SUBJECT: Provides addl response to NRC 800310 ltr re auxiliary feedwater sys design requirements. Licensee response to generic recommendations & basis for auxiliary feedwater sys flow requirements encl.

Subject: Palo Verde Nuclear Generating Station (PVNGS) Units 1, 2 and 3
Docket Nos. STN-50-528/529/530
File: 81-056-026

BASIS FOR AUXILIARY FEEDWATER SYSTEM
FLOW REQUIREMENTS

Figure 4

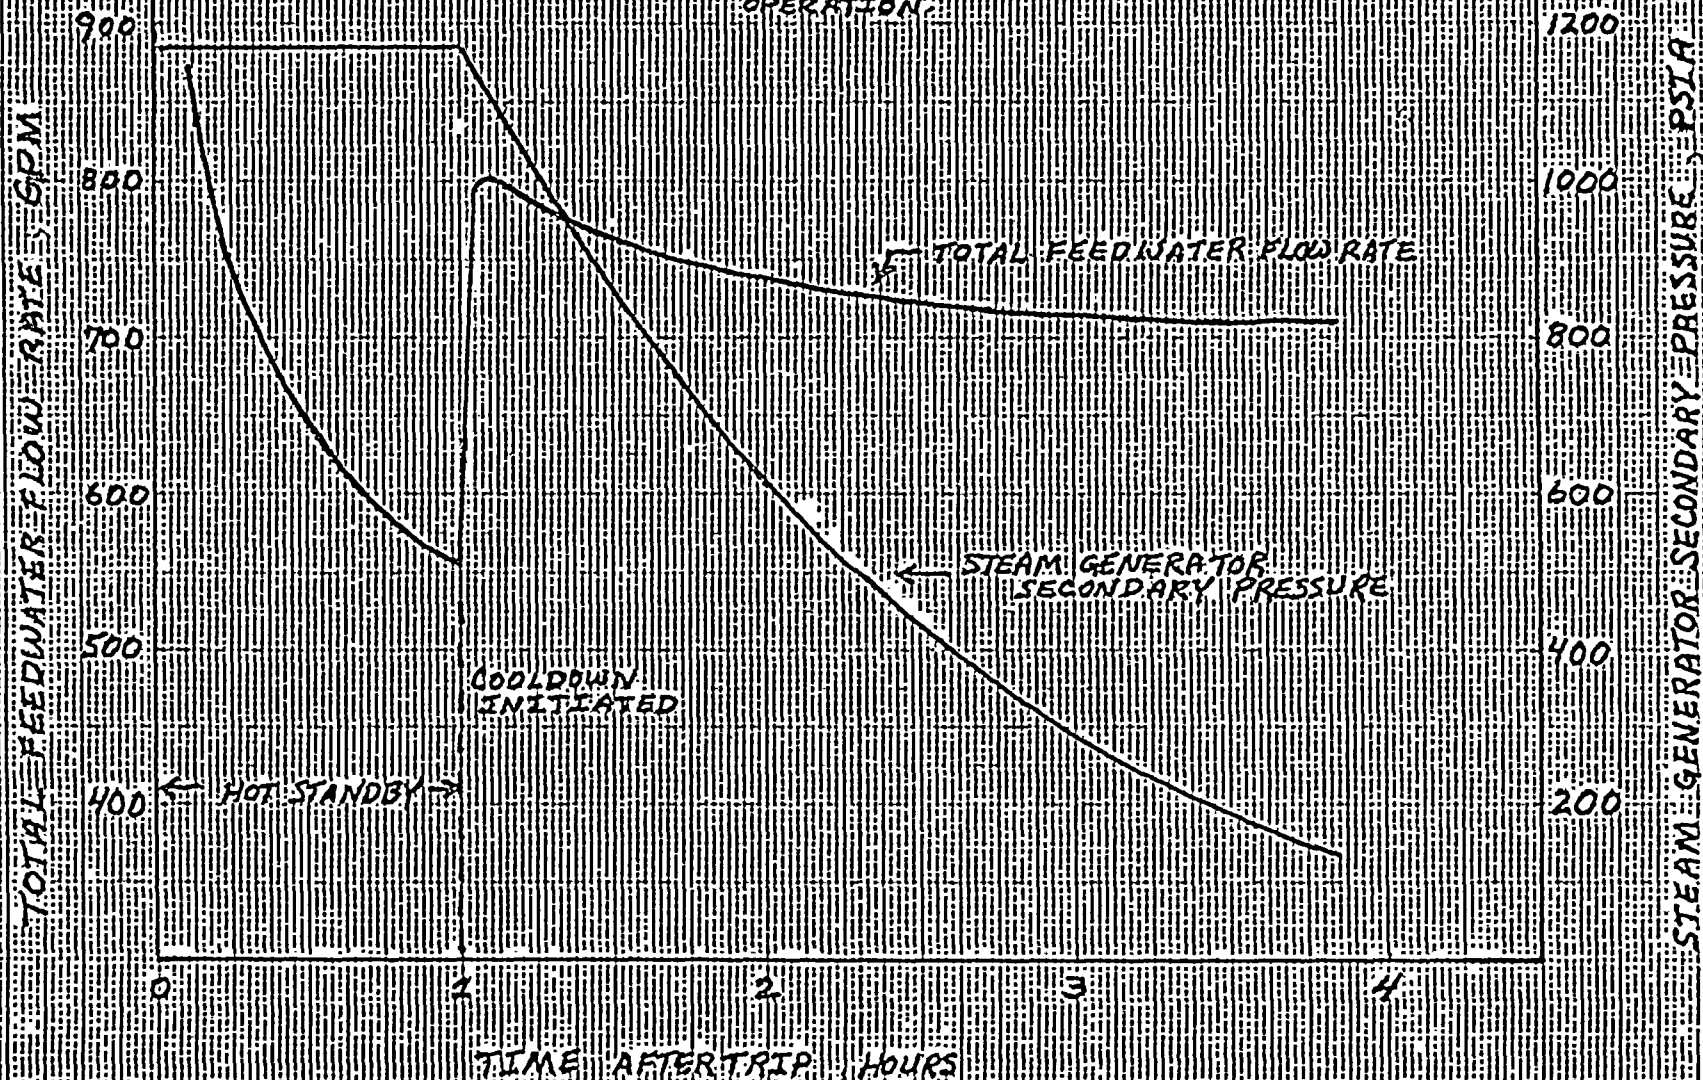
4) Plant Cooldown

The feedwater flow rate necessary to equal steam flow for a plant cooldown is shown in Figure 1.
